893 Cayuga Heights Road  
Ithaca, NY 14850  
January 31, 2016

Re: Additional comments on DEC Application ID#0-9999-00075/00001 (Cargill Mine Shaft #4) focusing on Spectra Environmental Group's Well Survey

These comments, which supplement my comments dated December 9, 2016, focus on why DEC should require Cargill to produce a new well survey.

Figure 1. Strike of Four Major Joint Sets in the Finger Lakes Region.

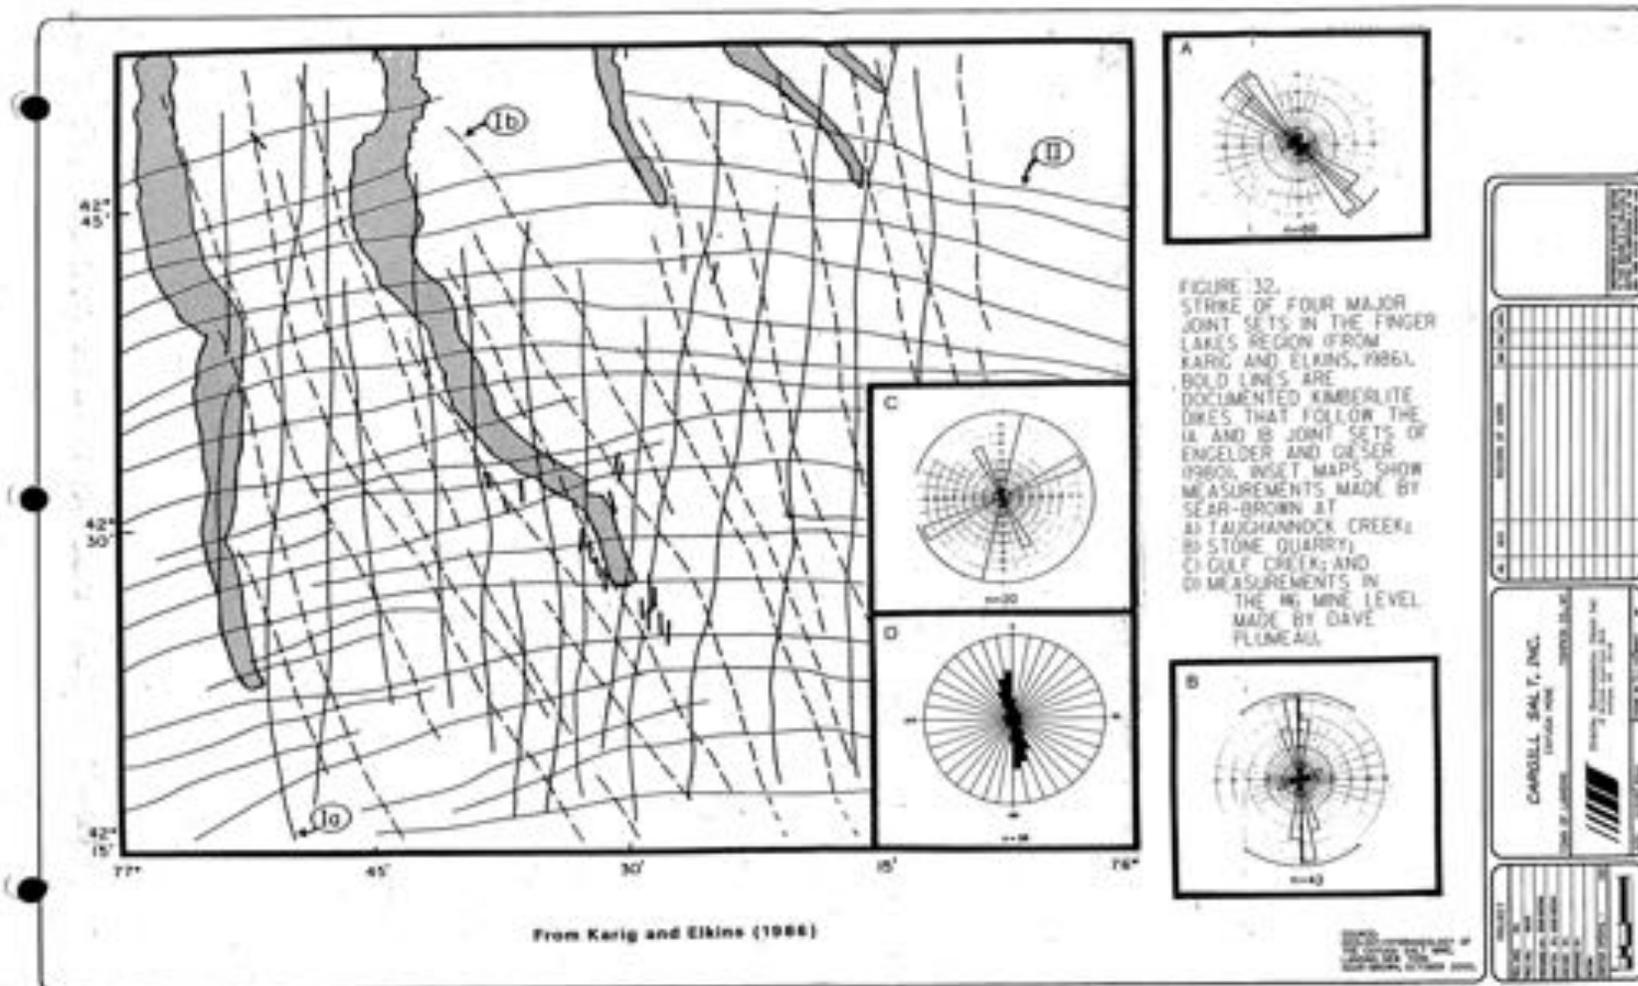
**JVD:** Figure 1 below shows major joint sets in the central New York area. These joint sets offer one means of hydraulic connectivity between shallow groundwater resources and deeper groundwater resources. Figure 2 below shows a depiction of the likely shallow groundwater flow regime in the area of Cargill’s operation at Portland Point. The flow regime south of Waterwagon Road may be analogous to the topography at Cargill’s proposed Shaft 4 location: water moving consistently downgrade toward the lake through glacial till.

of serial glacial loading and unloading. It is these north-south running fractures and joints that would be more likely to determine the extent of water table draw-down events related to the proposed construction of Shaft 4 and to expected leakage into the shaft subsequent to the proposed construction.

Figure 3. Profile B across Cayuga Lake (source: Sear Brown. 2000. Geology/hydrogeology of Cayuga Salt Mine. Lansing, NY.) scale in original image: 1" = 400'

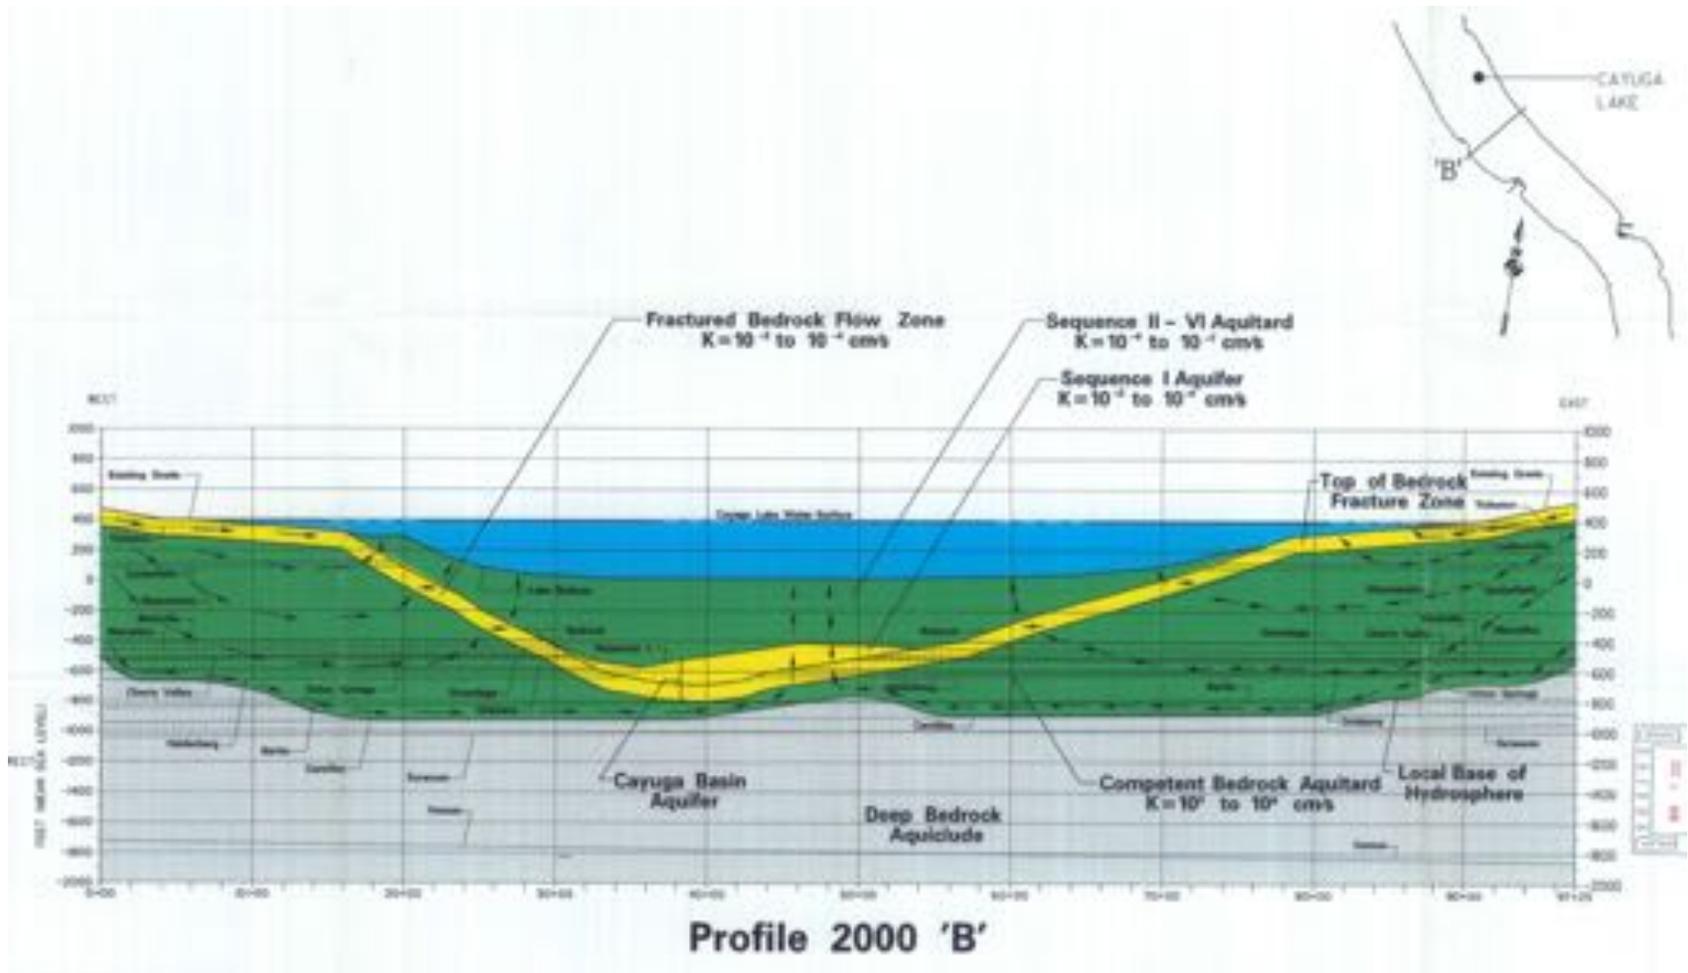
**JVD:** Figure 3 below is known as Plate 3.1-9 Profile B in a year 2000 Spectra document. It shows the expected groundwater flow patterns as ground waters approach Cayuga Lake from bedrock zones located to the east and west of the lake. This “section” reaches the east shore of Cayuga Lake between Lansing Station Road and Sweazey Road, i.e, more or less due west of Cargill’s proposed Shaft 4 project. In this figure, the hydrosphere—shown in green and yellow—is essentially continuous down to the Oriskany formation located in this figure at about 1,100 feet below grade at the far left of the figure.

Consultation with geologists suggests two possible explanations: road salt and venting of brine from the top of bedrock fracture zone which is understood to contact the first 1500 feet of the lake floor when going west from the shore (Profile B on the page above).

**Brine venting to the lake shore area.** “Profile B” (page 21 above), which Spectra included in one of their year 2000 documents (Spectra, 2000, Vol II) shows the near-shore bottom of the lake to be in direct contact with a water-bearing “top of bedrock fracture zone,” with this contact area going west from the eastern lake shore about 1500 feet. The east end of Profile B is roughly midway between Lansing Station Road and Sweazey Road, or about 0.5 miles north of the contaminated Campbell beach well.

Figure 4. Existence of an “artesian aquifer” under Cayuga Lake as interpreted from 1995 Cargill Seismic Data. Source: Plate 3.1-8 in Spectra Environmental Group. 2000. Volume II.

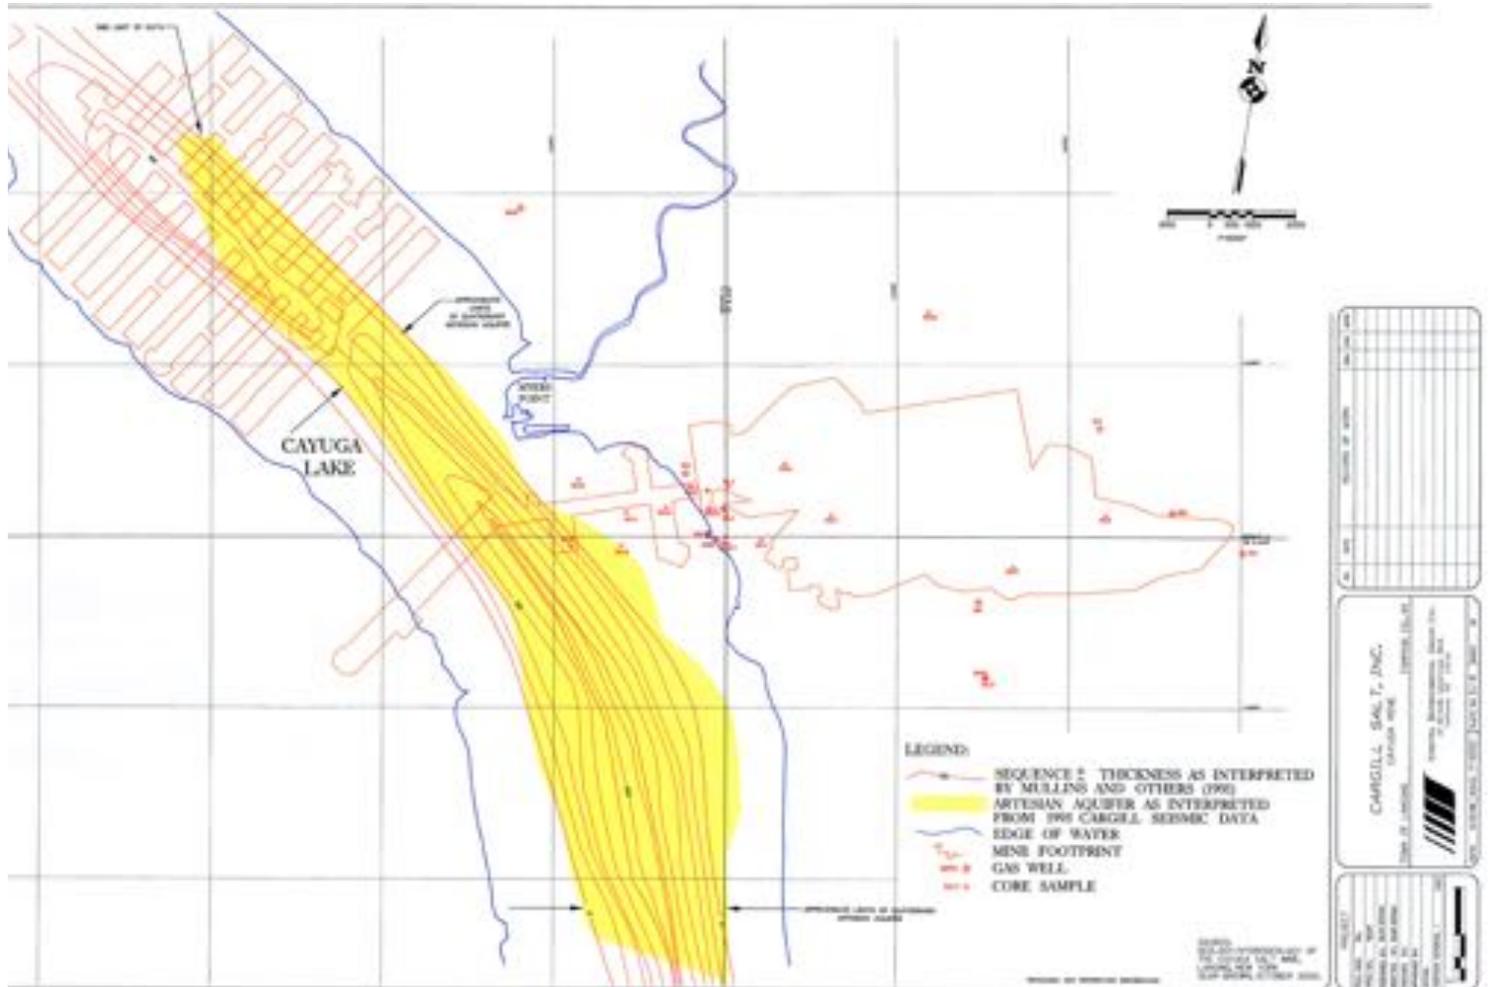
Assuming that similar direct contact between the top of bedrock fracture zone and the lake water column also exists in the vicinity of the contaminated Campbell Beach Well at 367 Bill George Road, there exists the reasonable possibility that the salinity found at the bottom of this well is the result of brine venting from the artesian aquifer shown to exist under Cayuga Lake in seismic data run by Cargill in 1995 (Sear-Brown. 2000).

Figure 4 above shows in yellow the southern extent of an artesian aquifer under Cayuga lake. But, is this aquifer definitely saline? Analysis of water samples taken from the water-bearing Oriskany formation encountered at about 1490’ below grade during the Corehole 18 drilling in 2013 resulted in chloride figures of 95,900, 130,000 and 220,000 mg/L and tritium levels of 0.84, 1.94, and 15.5 TU. The samples were taken about a month apart and the third sample was considered by the RESPEC authors to be the least contaminated by drilling fluids. It should be noted that the Corehole 18 borehole was located about 0.7 miles ENE of the lake shore and about 1 mile due east of where Profile B meets the east shore of the lake. The RESPEC authors wrote,
